RIGOH	Technical Bulletin			No. RTB-001
SUBJECT: Black Ink Cartridge S	eal			DATE: Sep. 30,'91 PAGE: 1 of 1
PREPARED BY: S.Asai CHECKED BY:		FROM: Copier	Technie	cal Support Section
CLASSIFICATION: Action Required Troubleshooting Retrofit Information	Action Required TroubleshootingRevision of service manual Information onlyVT35 Ges			
To increase ink production, the transparent seal will be removed from the exit of the black ink cartridge (500cc and 800cc ink). For the color inks, the transparent seal remains because the color inks are more fluid than the black ink. Due to this change, the instructions printed on the black ink cartridge will be changed as shown below.				seal remains
OLD Handling instructions Remove the Cap A from a new cartridge of in remove the Seal B. Set ink cartridge. Manuel d'Instruction Retirer le bouchon de la nouvelle cartouche of Ne pas retirer le joint B. Mettre en place la cartouche d'encre. Bedlenungshinweise Kappe a von neuer farbpatrone entfernen. Farbpatrone einsetzen. Instrucciones de manejo Extraiga la tapa A del nvevo cartucho de tinta. No extraiga el precinto B. Coloque el cartucho de tinta. Modo di Implego Rimuovere il coperchio A dalla nuova ca

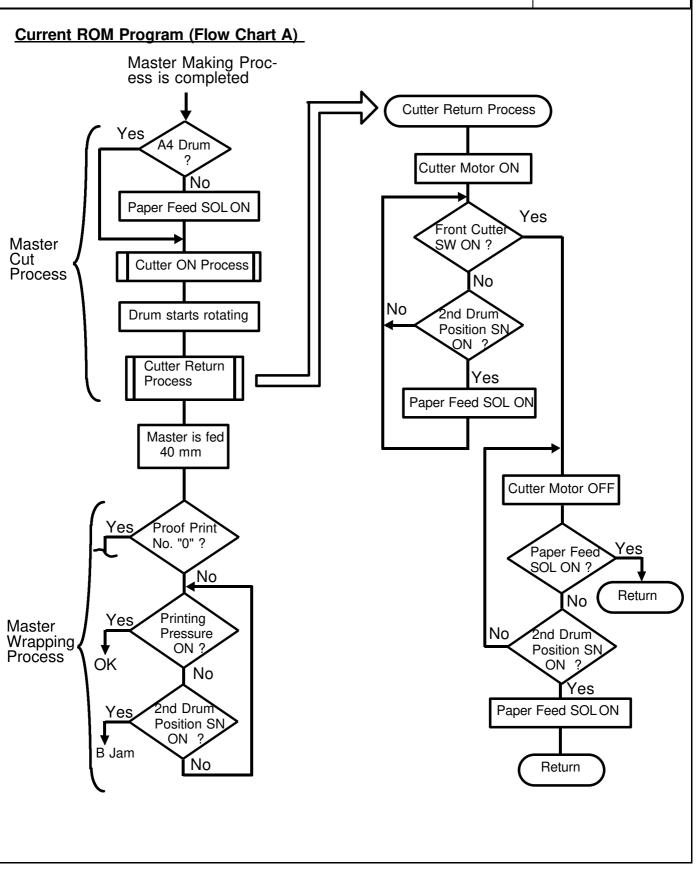
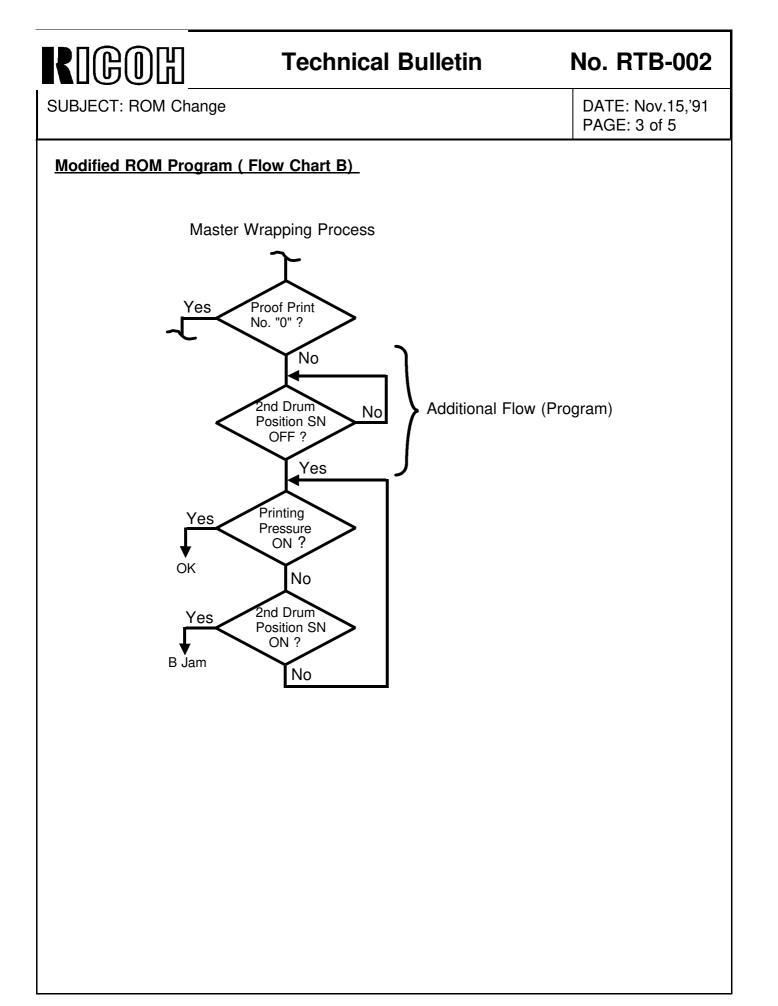
There has been reports in the field of the B jam with the A4/LT optional drum because the paper feed solenoid does not turn on at correct timing. This problem only occurs in proof mode (trial print) when the optional A4/LT drum is installed. Therefore, when the proof print number is set to zero with SP mode 81, the problem (B jam) disappears. Please note that this problem does not happen very often. One circumstance when this occurs is when the drum rotation is delayed due to an overload.

On the A3 drum, the paper feed solenoid turns on when the master making process is completed. However, this ON timing is too early for the A4/LT drum. Therefore, on the A4/LT drum. the paper feed solenoid turns on when the 2nd drum position sensor turns on.(Normally, the 2nd drum position sensor turns on while the cutter returns to the home position. Then, the process proceeds to the master wrapping process.) But, if the drum rotation is delayed due to an overload, a paper jam is detected during the master wrapping process because the 2nd drum position sensor ON timing is delayed. Normally, the 2nd drum position sensor should be OFF at this time. (See the attached flow chart A.)

To prevent the above problem, the ROM program relating to the master wrapping process has been modified. During master wrapping process, the paper misfeed is detected after the 2nd drum position sensor turns off. (See the attached flow chart B.)

SUBJECT: Damage of Optional A4 Drum

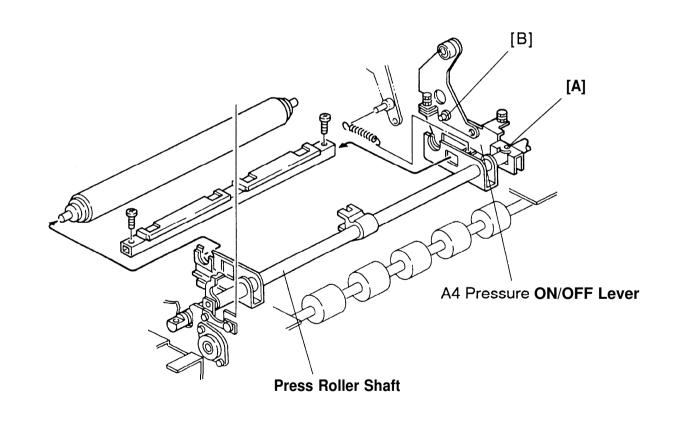
It was reported that the bolt (M5x14 hexagonal hole head bolt) that secures the A4 pressure on/off lever on the press roller shaft breaks. This will cause the exit pawl to hit the drum surface because the exit pawl drive cam is fixed with the A4 pressure on/off lever.

Since August 1992, the torque to tighten the bolt has been reduced and controlled to 40 to 50 kgfcm on the production line. In the past, it was around 100 kgfcm. It was found that there was possibility of the bolt breaking while using the optional A4 drum. The cut-in serial numbers are as follows:

1. Replace the bolt [A] with a new one (P/N: 05950140E).

2. Be sure that the bolt [B] (M4x6 hexagonal hole head bolt) is firmly tightened. If this is loose, the A4 pressure on/off lever does not operate properly.

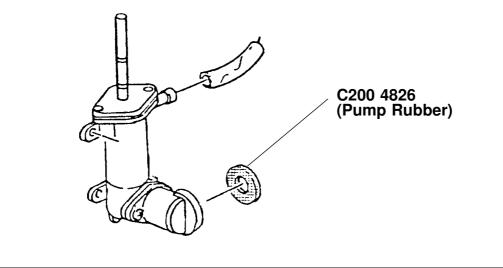
There are two types of spring for these three types of the ink pump. The part numbers are:

C222 4710 (Pump Spring - 21 mm) : For the NA/NB type ink pump.

C224 4715 (Pump Spring - 13 mm) : For the N and N810 type ink pumps.

For the field machines, you can install the spring after removing the socket (with two screws). (It takes longer to replace the whole pump assembly.)

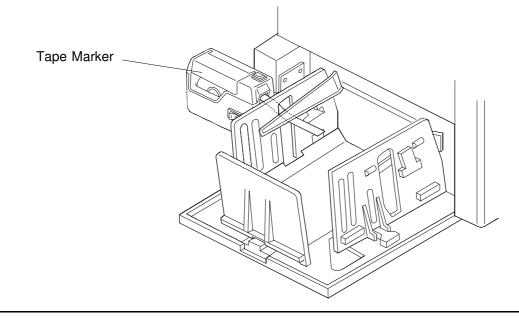
Upper Guide Plate						
 Thanks to the newly added small guide plates on the upper of each front and rear side fences, the copies are more evenly stacked on the table. Both edges of the copy are guided by the small guide plates as the copy is fed out. Then, the copy is correctly directed to the end plate for stacking. 						
Continued

The end plate is also new. The material and configuration of the cushion have been changed. The new end plate better receives the copies for stacking. (The 2nd end plate, which is for the smaller sized paper, remains the same.)

Motor Relay Harness Kit: P/N-C223 8131

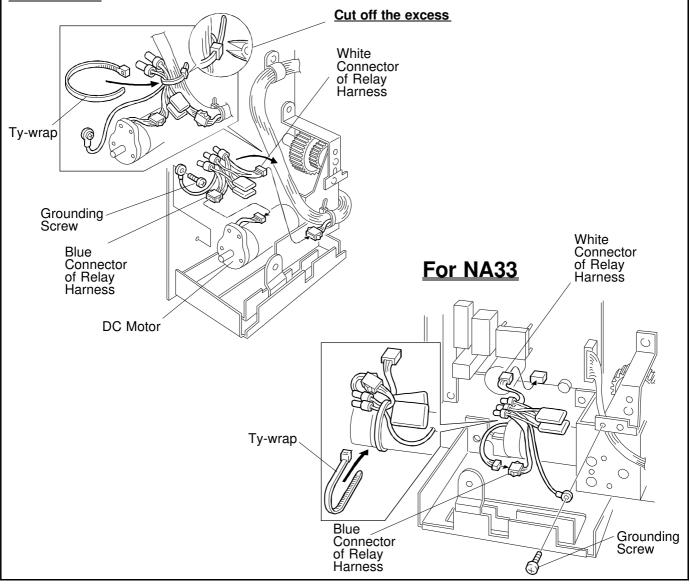
The dc motor that drives the table occasionally generates electrical noise when it starts rotating. This electrical noise is input into the ac drive board and damages IC301 on the board.

To prevent the electrical noise from being generated, a harness which contains two capacitors will be installed between the ac drive board and dc motor from the August 1996 production.

In the field, install the kit as shown below:

- The layout of the dc motor is slightly different between the N850 and NA33 models as shown. To prevent the relay harness from being caught by the gears, firmly secure it with the Ty-wrap as shown in the illustrations for each model. NOTE: _
 - -Since the Ty-wrap is too long for the N850 model, cut off the excess, as shown.

For NA33 model

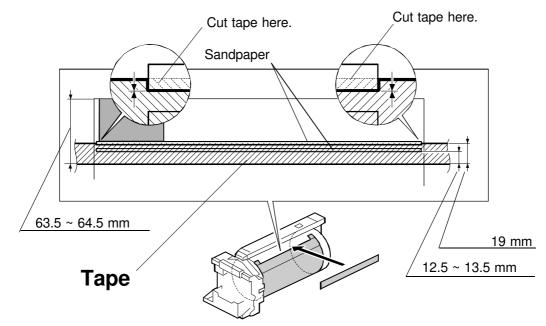
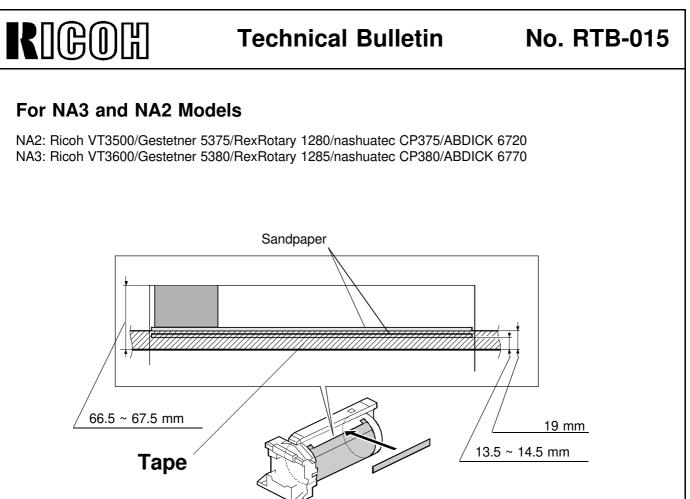
- Cut the tape where it covers the upper strip of sandpaper as shown. Be careful not to damage the cloth screen surface.
- Cut both edges of the tape at the edge of the <u>metal screen</u>. Do not let the tape ride over the drum flanges.

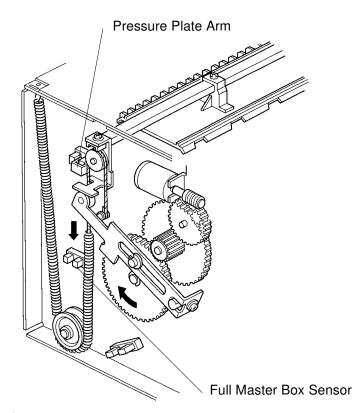
Old Part Number	New Part Number	Description	Interchangeability
C209 3533	C227 3533	Pressure Plate Arm	X/O

The new part has a narrower actuation plate as shown below. This means that the full master condition will be detected earlier than before.

If SOLUTION 1" is not good enough, install the new part on the operation side of the master eject unit (see below).

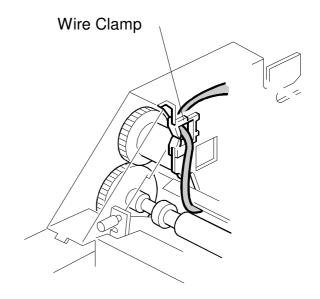
From the April 1998 production, a wire clamp is installed on the plotter unit frame to fix the wire, as shown to the right. (The part number of the frame remains the same, although the cutout for the clamp has been added.)

<u>Case 1:</u>

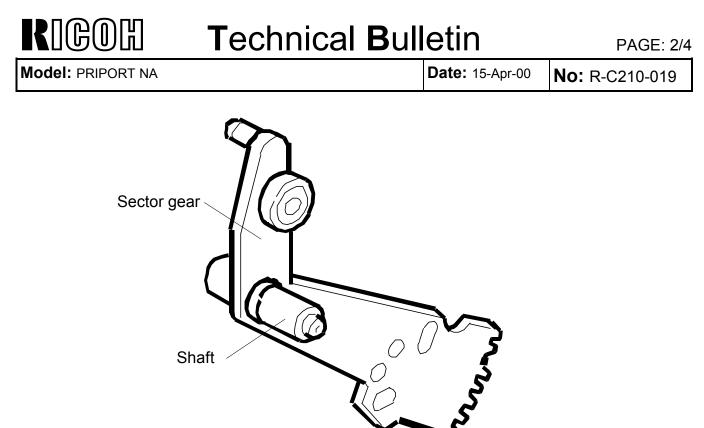
The sector gear [A] and the feed roller gear [B] ran out of lubricant. Because of this, the sector gear [A] will not be able to oscillate back and forth correctly.

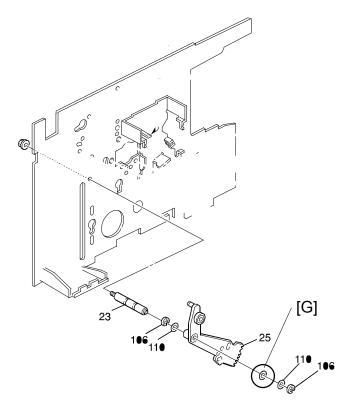
Solution 2:

Add some spacers to remove the play.

Add 1 or 2 additional spacers [G] on the front side, as shown above.

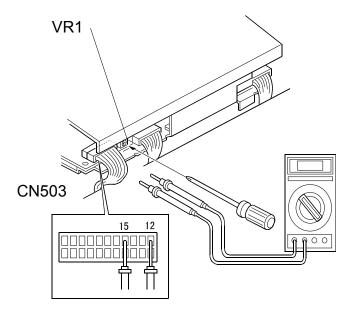
Please add the following adjustment procedure in section 5 of the C228 manual. The adjustment standard is different between the NA33 and NA6 models.

Purpose: To ensure proper paper feed by the second feed rollers.

Adjustment Standard: 55 to 60 mm

- 1. Stack about 100 sheets of paper on the paper table.
- 2. Set the paper table in the paper feed position (Use output check mode SP131, No. 19). Then, turn the main switch off and unplug the machine.
- 3. Remove the rear cover and the drum unit from the machine.
- 4. Turn on the paper feed solenoid manually, then gradually turn the drum rotation shaft with a 10 mm spanner.
- 5. Measure the paper feed length from the time the second feed roller starts rotating until it stops rotating. This feed length should be between 55 and 60 mm.
- 6. If it is not, adjust the feed length by loosening the screw and shifting the cam up or down.
- 7. Check the adjustment by repeating steps 4 and 5.

NA33 service manual Page 5-74

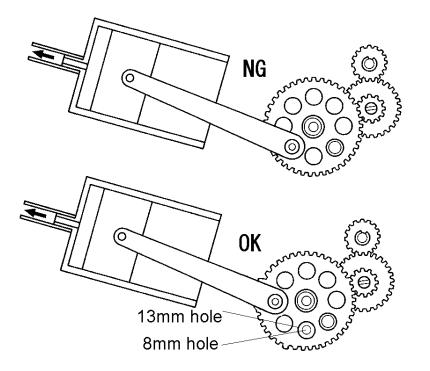
Please correct the procedure as follows. The 13 mm hole in the gear should be at the 6:00 position. (See below.)

- 1. Open the front door and remove the inner cover.
- 2. Press and hold down the 'Drum rotate' button until the drum reaches the home position.
- 3. Confirm that the 13 mm diameter hole in the gear and the 8 mm diameter hole in the side plate are lined up at the 6:00 position.
- 4. If the holes are not lined up, remove the E-rings and reposition the gear.
- 5. Rotate the drum to the home position and do step 3 again.
